HARTFORD PUBLIC LIBRARY
HARTFORD, CONN.
VIERENDEEL TRUSSES "D" & "E"

IN CHARGE OF CL	DATE	CONTRACT NUMBER 4082	
DRAWN BY CTD	DATE 12 Oct 54		
CHECKED BY RCC / R.E.	DATE 11-10-54	SHEET NUMBER AD1	
SCALE

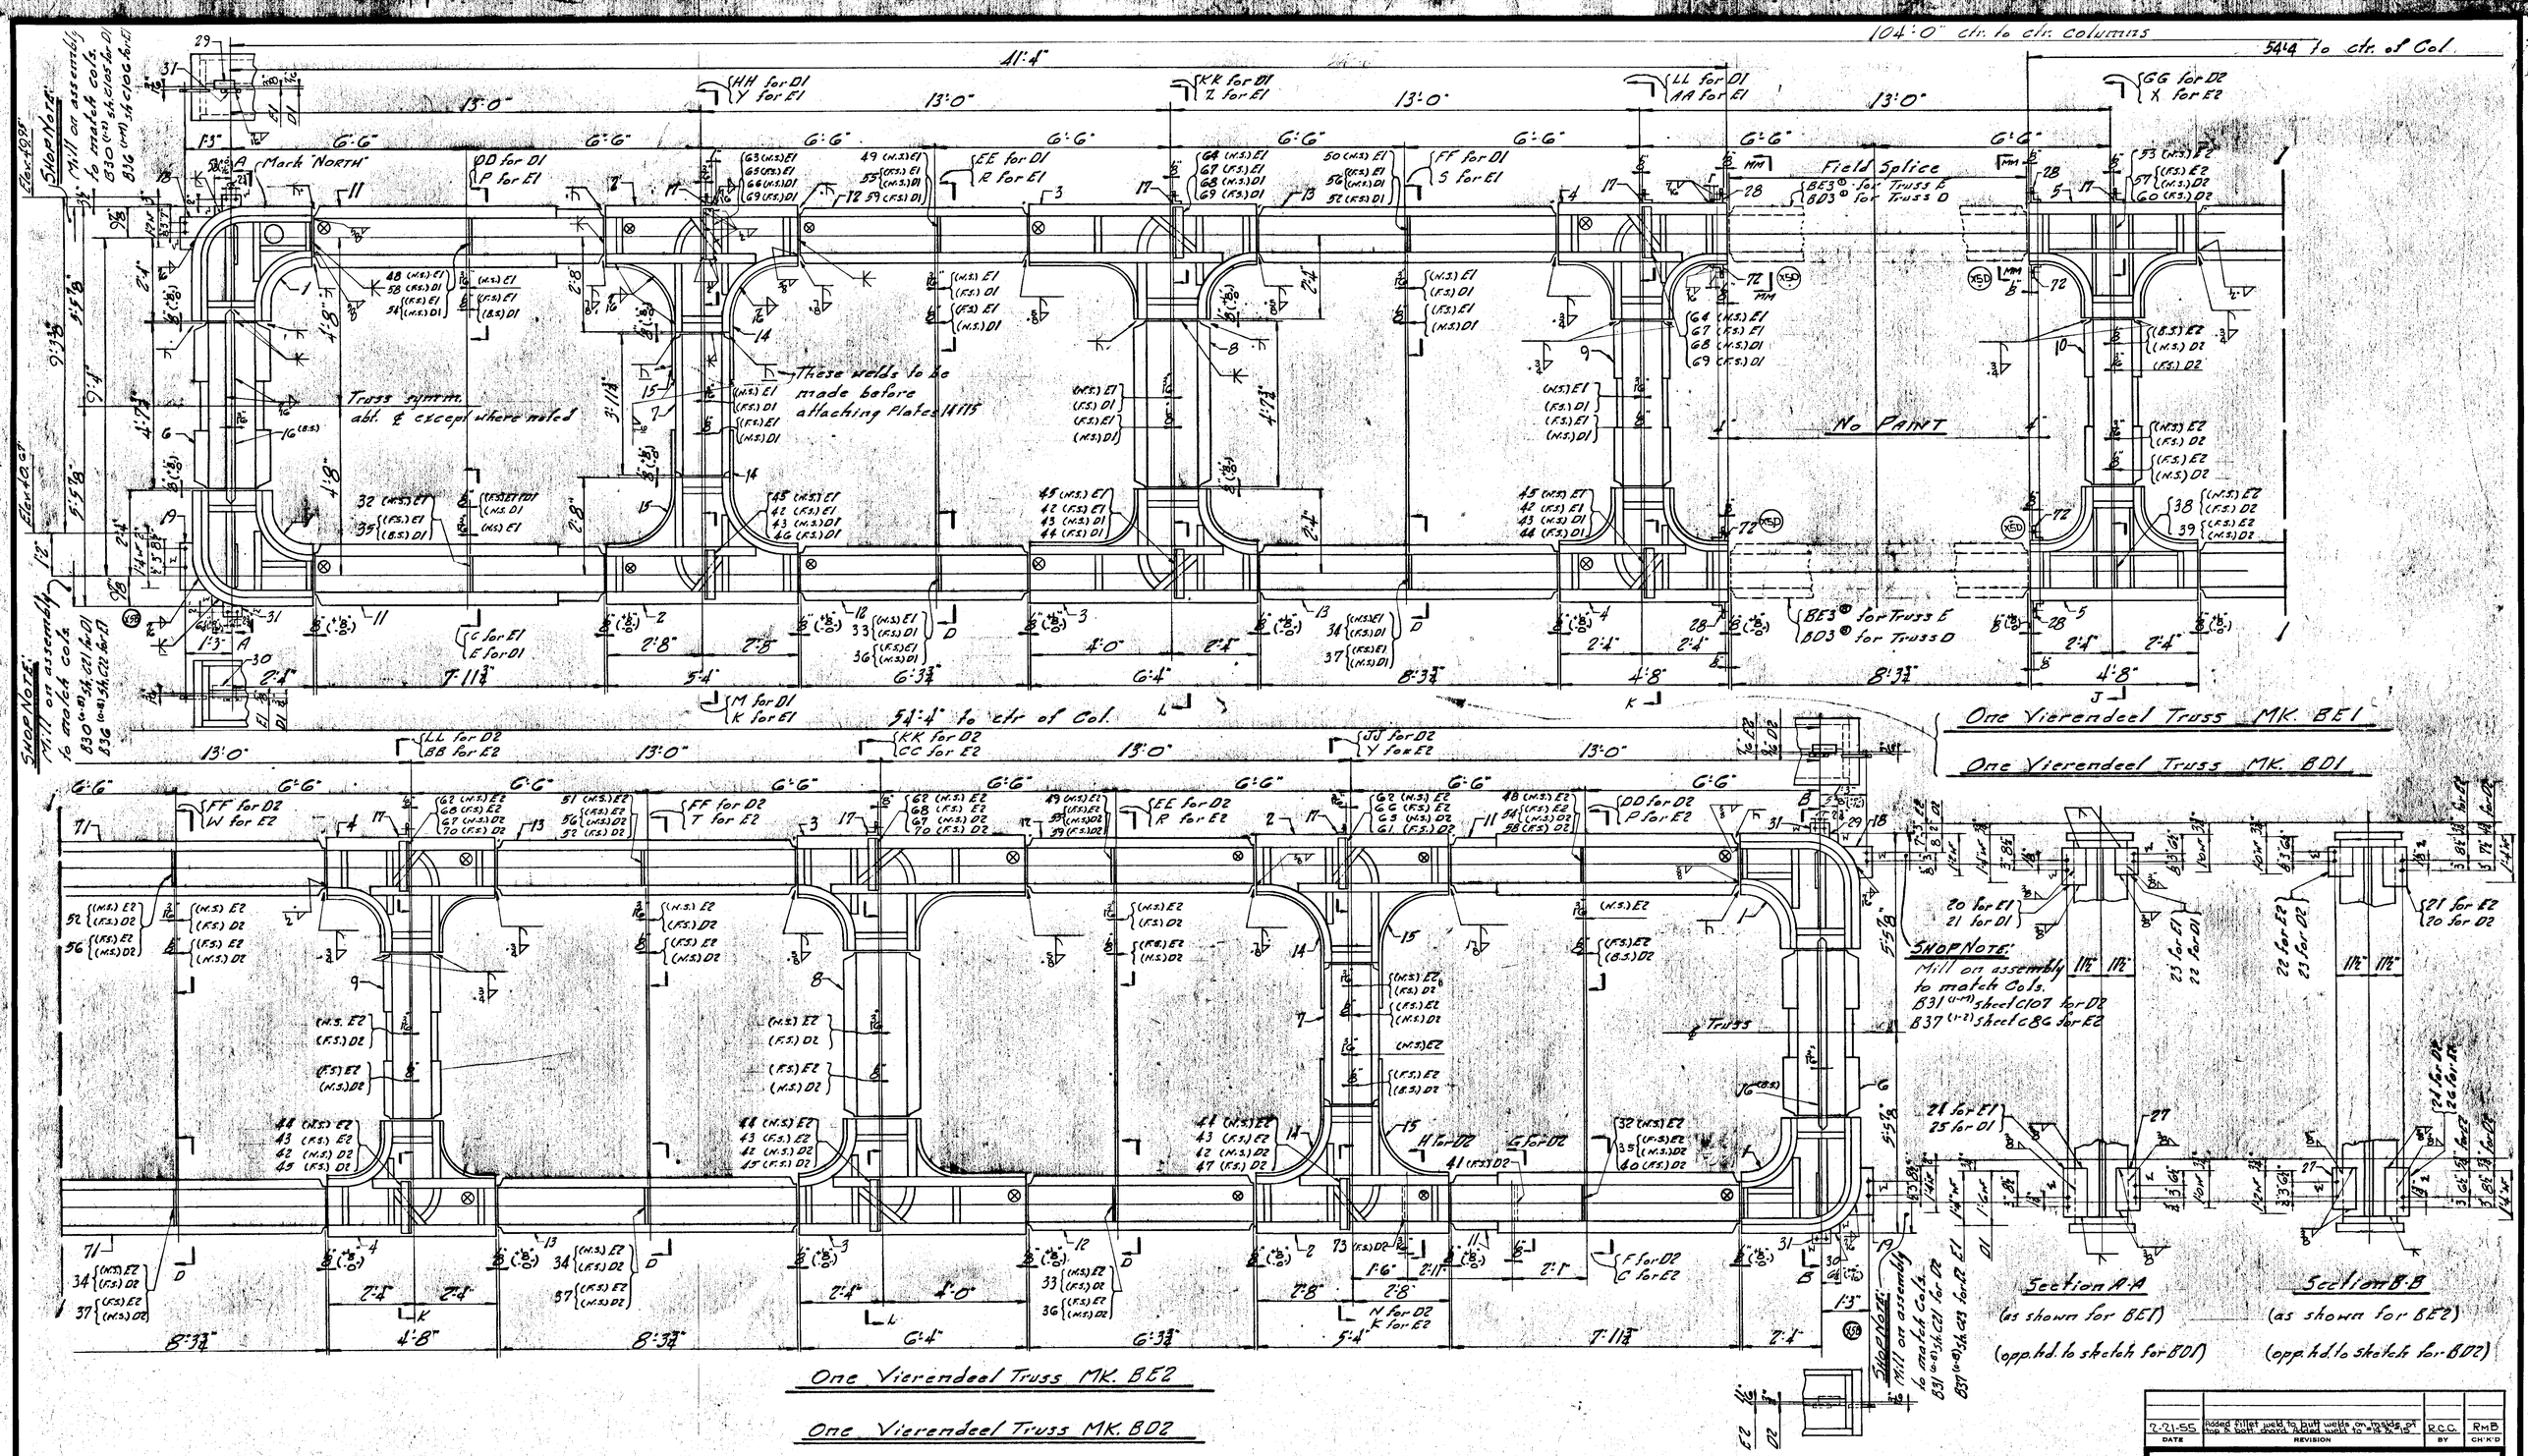
DATE	REVISION	BY	CH'K'D
2-21-55	Added fillet weld to butt welds on inside of top & bott. chord. Added weld to 18 & 19	RCC	RMB
